U.S. Nuclear Regulatory Commission

Research Information Letter 12-01

Confirmatory Analysis of Seismic Hazard at the
Diablo Canyon Power Plant from the Shoreline Fault Zone

September 2012

Figure 4-3 Seismicity and recurrence curves for the Shoreline fault
(Figure 4-3 of the PG&E Shoreline Fault Report, annotated with
the curves appropriate for a creeping fault).

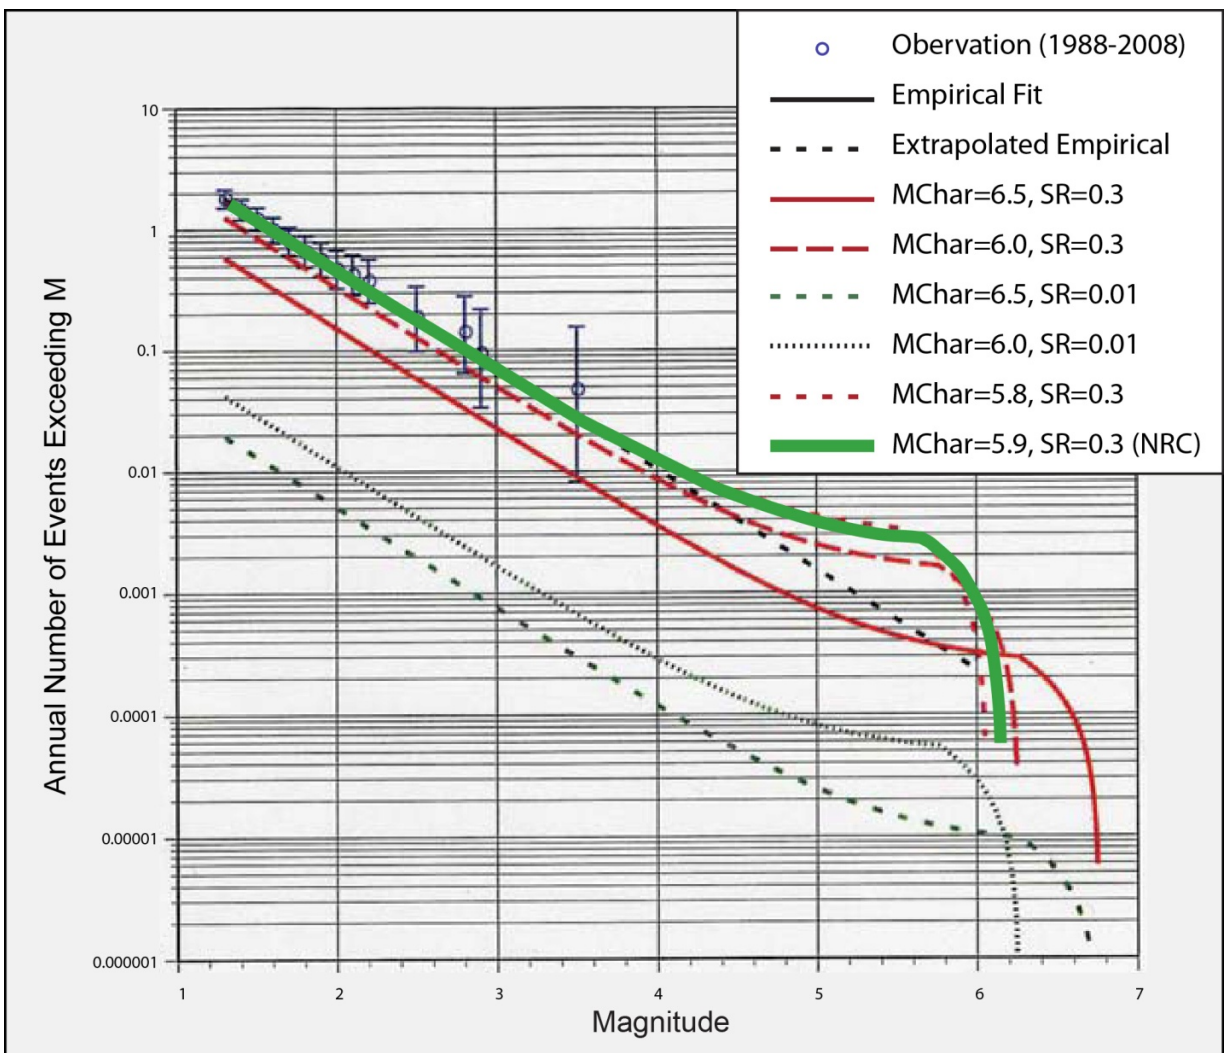
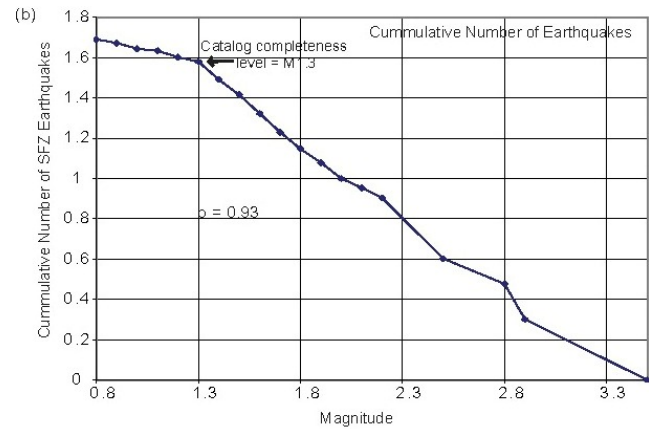
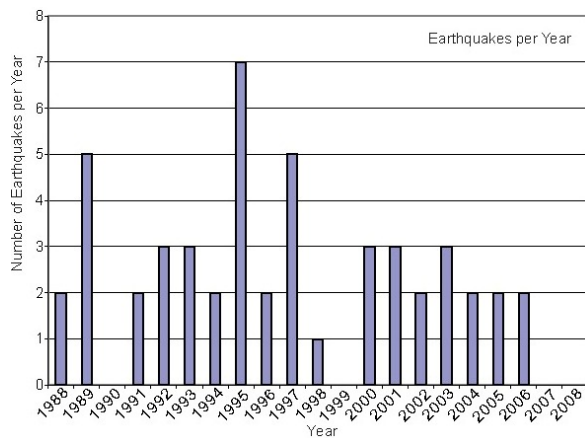
Figure 4-3 in this document is an annotated version of Figure 4-3 in the Shoreline Fault Report. This figure shows the number of earthquakes recorded per year (in the upper left), the cumulative number of earthquakes recorded in each magnitude bin (in the upper right) and the calculated catalog completeness, and the magnitude recurrence curves for various maximum magnitudes and slip rates overlain on the recorded data (in the lower half). However, none of the characteristic magnitude/slip rate combinations shown in Figure 4-3 fit the data when the lack of observed surface displacement is considered. Instead, the current rate of seismicity of small earthquakes and the lack of visible offset would be explained by a combination of a lower characteristic magnitude and lower slip rate. This supports a Shoreline fault model with a smaller M_{\max} .

Figure 5-7 Comparison of 2010 DCPD ISFSI velocity profiles to that of the 1978 velocity profile.

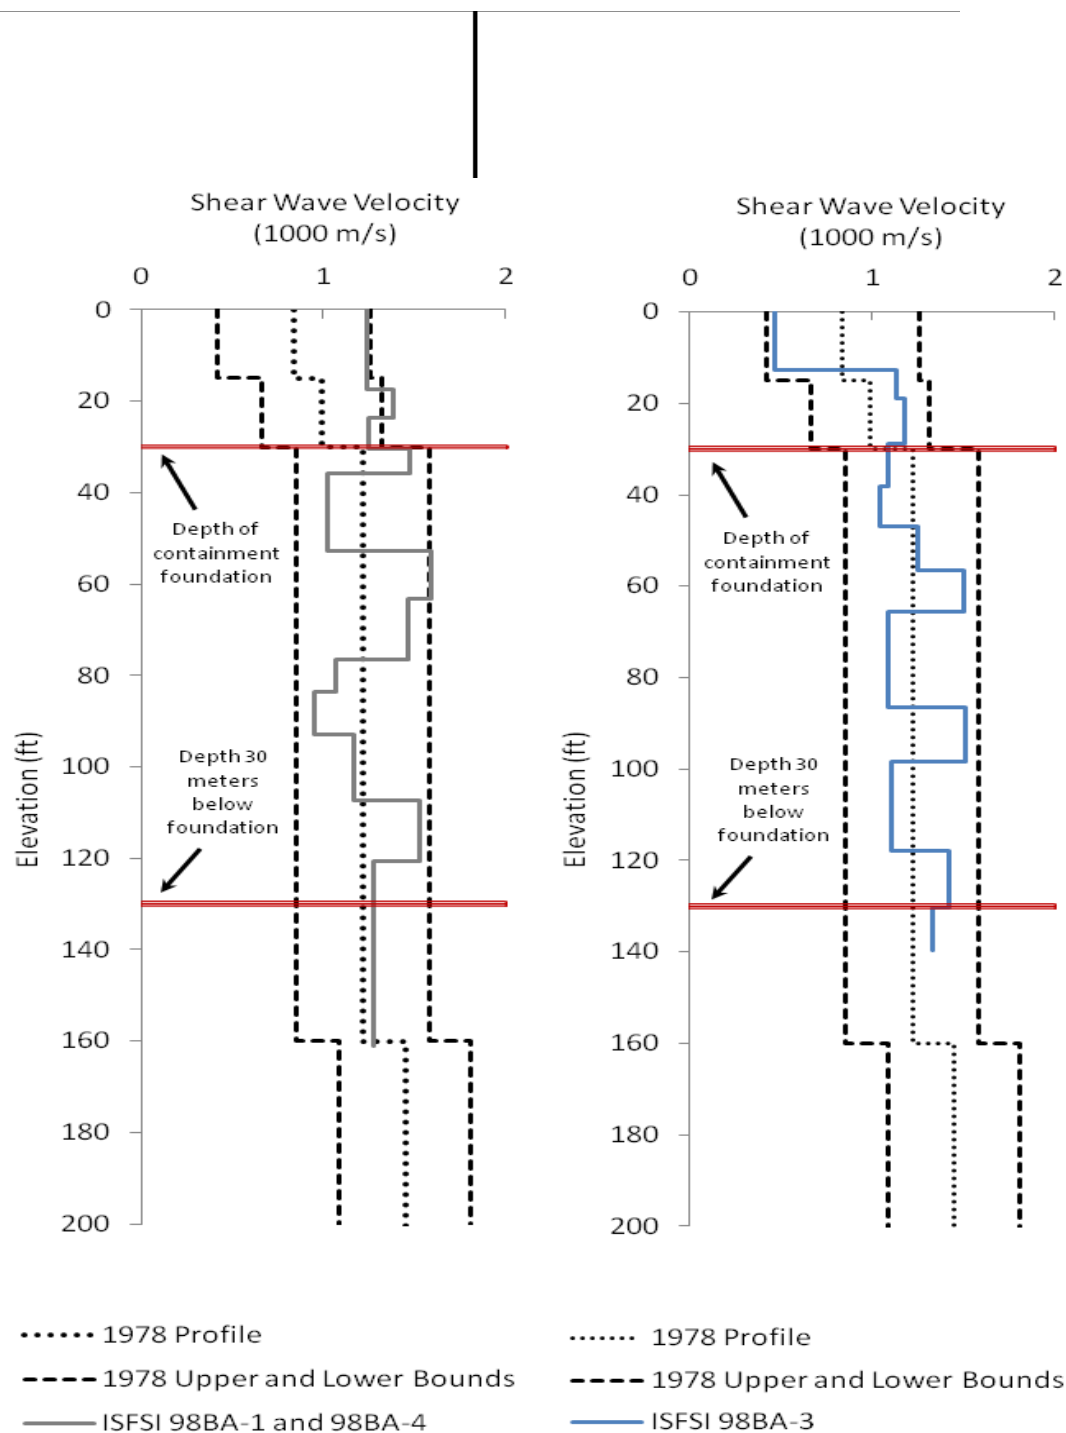
Using the ISFSI data, the NRC performed a review comparing the shear-wave velocity profiles obtained for the DCP in 1978 to those of the DCP ISFSI profiles collected in 2010, as shown in Figure 5-7. The objective of the analysis was to develop a best estimate of V_{S30} from the data obtained in 2010 using current methods and state-of-the-art equipment, and then to compare the results of the new study against the results of the 1978 study, which the NRC staff used in the preliminary analysis described in RIL 09-001.

Figure 5-11 Comparison of recording from 2003 San Simeon Earthquake at DCPP with predicted median ground motions from Graizer and Kalkan (2009) with and without site response correction factors of Silva (2008).

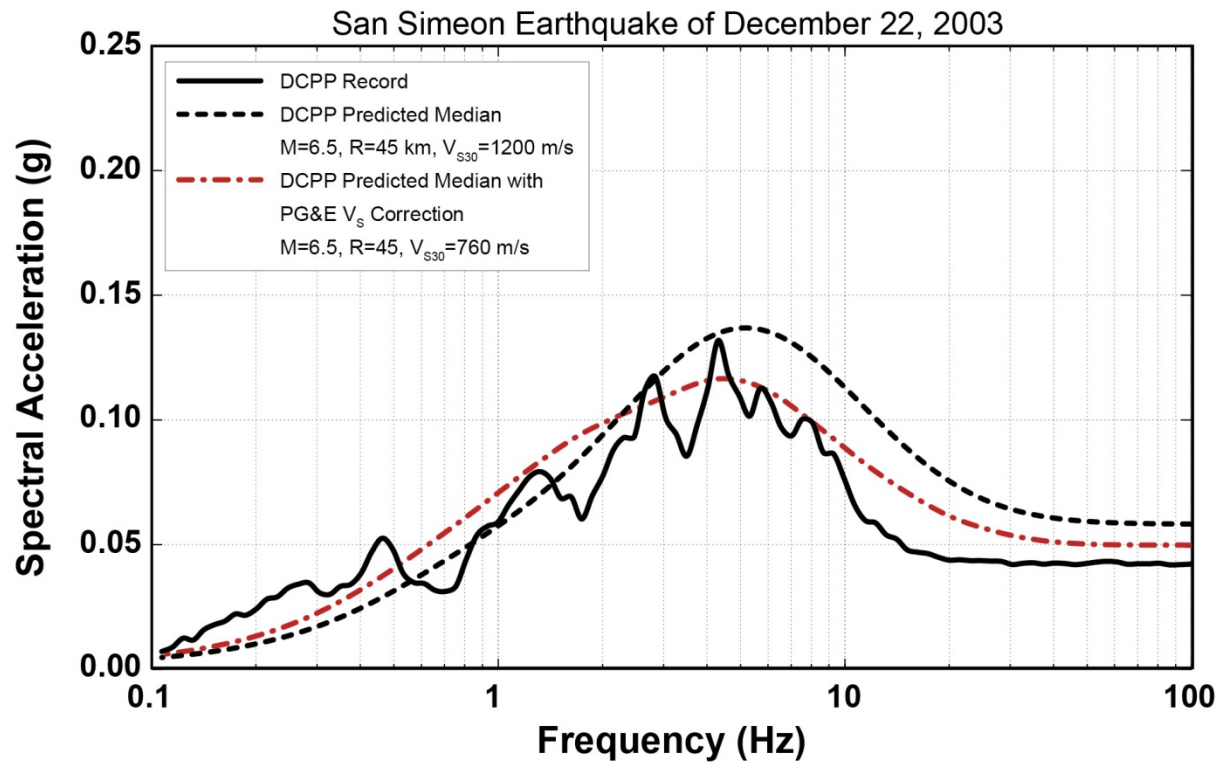
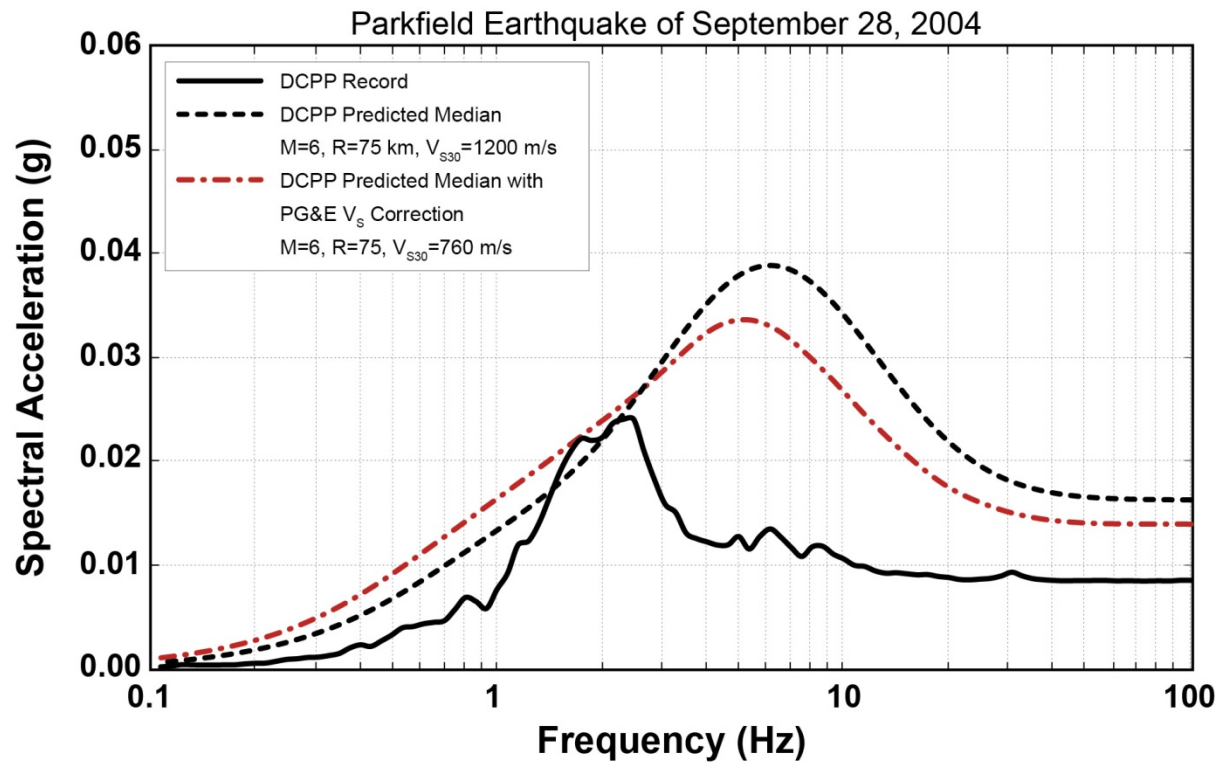
Figure 5-11 and Figure 5-12 present comparisons of the same DCPD recordings and the median ground motion prediction results of Graizer and Kalkan (2009) for two cases. One incorporates the shear-wave velocity based site response correction factors of Silva (2008) assumed for the site presented in Table 5-6 and described in Section 5.7.1, while the other uses V_{S30} directly in the GMPE. It can be seen that, in this instance, the site response based correction factors provide better agreement between the observations and the median⁵ estimates, particularly for the high-frequency portion of the spectrum.

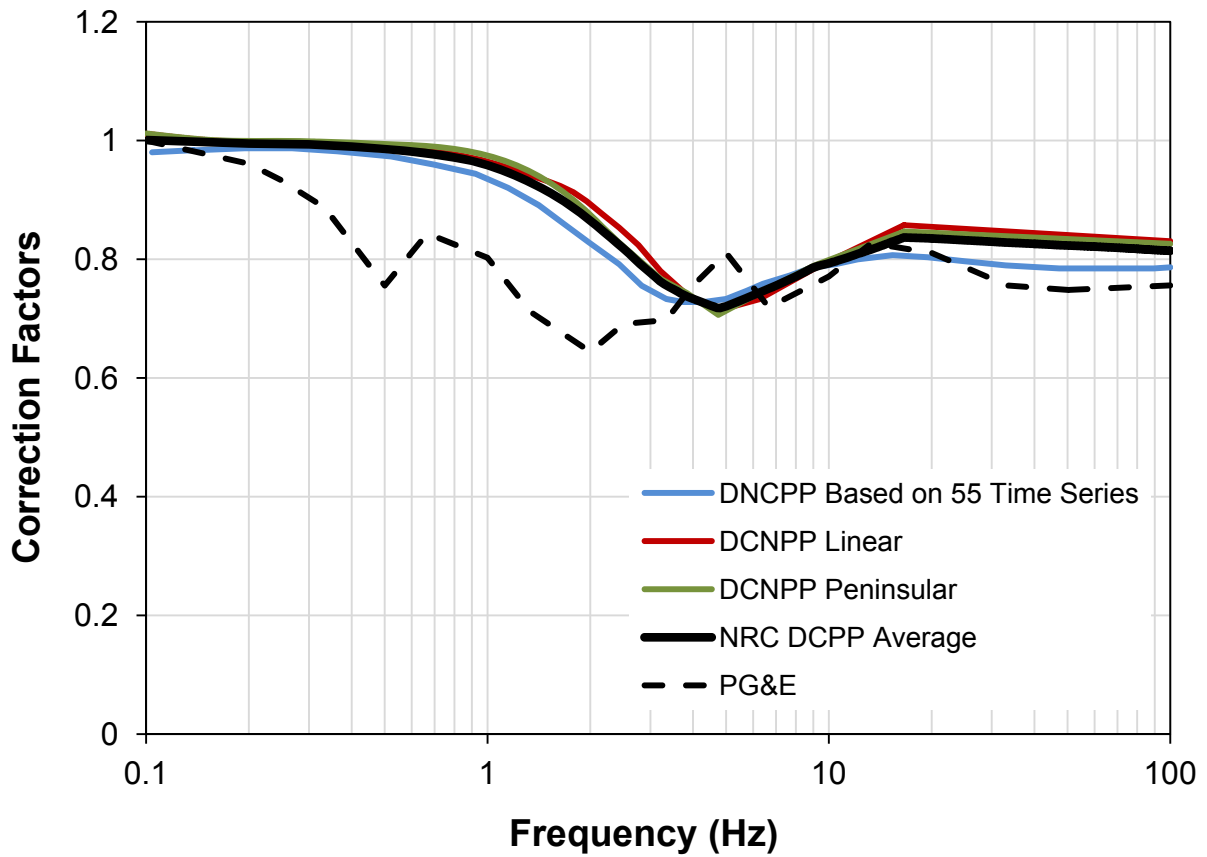
Figure B-8 compares the resulting correction factors for the time-series (TS) based approach and the RVT-based approach to those used by PG&E in the Shoreline Fault report. The results obtained using the TS and RVT approaches do not differ significantly from each other in this case. Since these two approaches represent two different, but both plausible, methodologies to perform this assessment, the NRC staff simply computed the arithmetic average of the three results to use in the deterministic analysis (shown as the heavy black line in Figure B-8). The correction factors used by PG&E in the Shoreline Fault Report are also shown in Figure B-8 as the dashed black line. As can be seen in Figure B-8, the NRC results are conservative relative to the PG&E results at virtually all frequencies.
